## Product Change Notice (PCN)

PCN Number: **PCN-0451204R-01**

Product(s) Affected: **PJ-057AH**

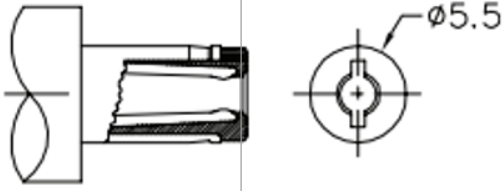
Description of Change: **Minor Housing and footprint differences. Material Change on the housing and terminals. See image Below**

PREVIOUS CUI DEVICE'S DETAIL / IMAGE			NEW CUI DEVICE'S DETAIL / IMAGE		
	MATERIAL	PLATING	DESCRIPTION	MATERIAL	PLATING/COLOR
center pin	copper	nickel	center pin	brass	nickel
terminal 1	brass	silver	terminal 1	brass t=0.40	silver
terminal 2	copper alloy	silver	terminal 2	bronze t=0.30	silver
terminal 3	brass	silver	terminal 3	brass t=0.40	silver
plastic	PBT		cover	PA10T (UL94V-0)	black
			housing	PA10T (UL94V-0)	black

**MATING PLUG**  
Jack Insertion Depth: **9.15 mm**

**MATING PLUG**  
Jack Insertion Depth: **9.45 mm**
